160-186 Lorimer Street, Docklands

Planning Permit Application No. PA1500010

Officer Assessment Report

Figure 6 - 'Saddleback' bedroom configurations

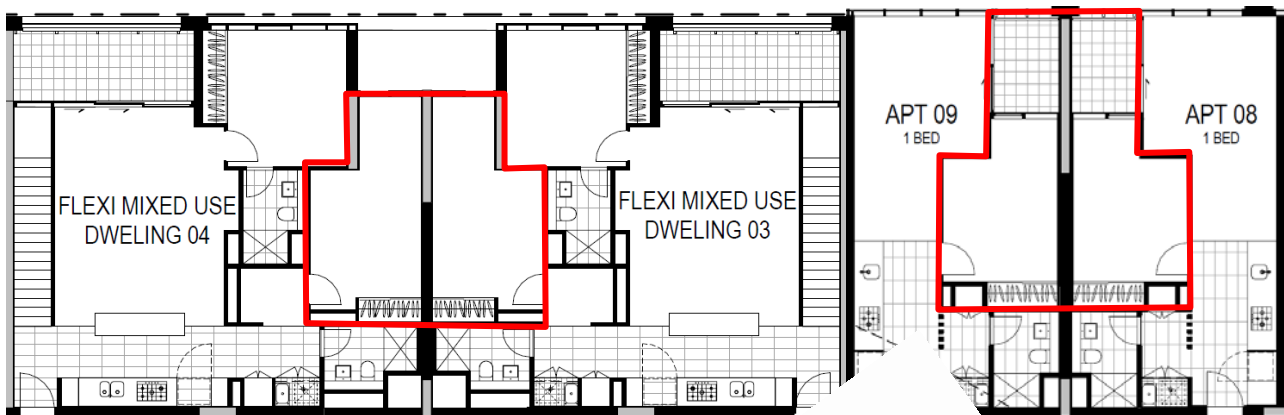
Within the podium levels, the north-facing typical apartments and flexi mixed-use dwellings incorporate 'saddleback' bedrooms (both configurations are shown below). These 'saddleback' bedrooms are considered to be acceptable. The internal dimensions of the bedrooms incorporate generous openings to the balconies or edge of the elevations to provide good daylight penetration to these dwellings. Furthermore, 'saddleback' bedrooms are only proposed for north-facing dwellings. The northern orientation, combined with the generous depth-to-width ratio, will ensure that all habitable rooms receive appropriate amounts of daylight.

Figure 7 - Rooftop communal area

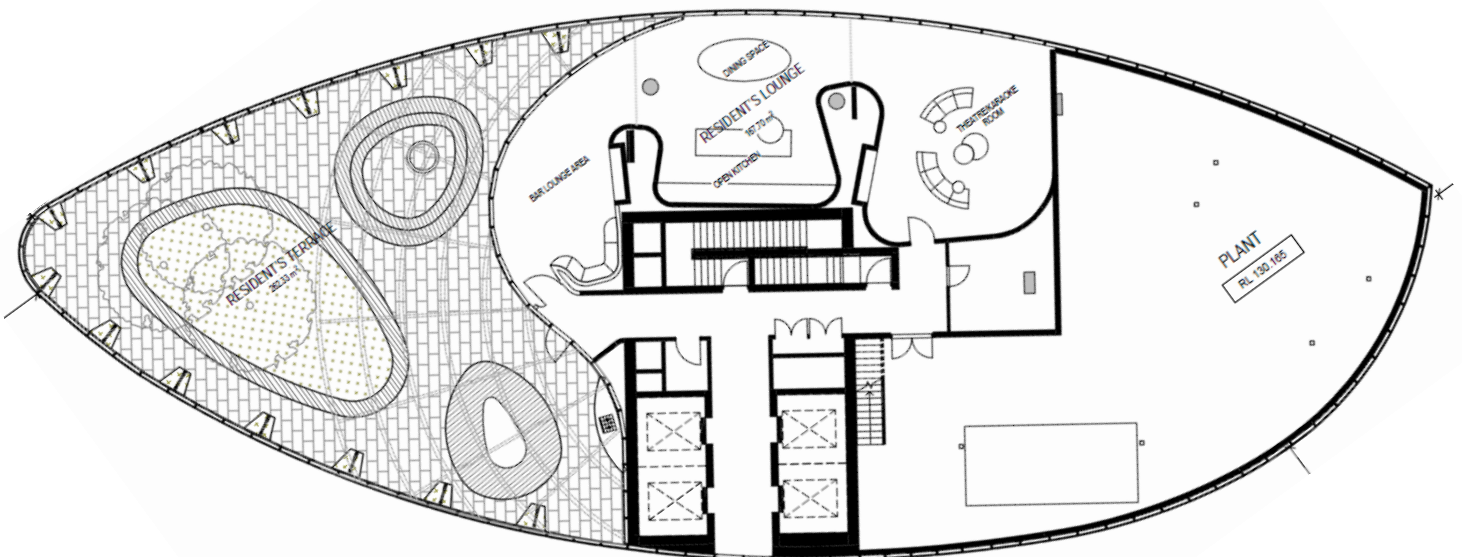
The proposed development incorporates a rooftop communal area of a suitable amount, type and location of the communal space to meet the reasonable recreation needs of the residents.

The rooftop communal area is located on the podium level. The area is designed to provide for the reasonable recreation needs of the residents.
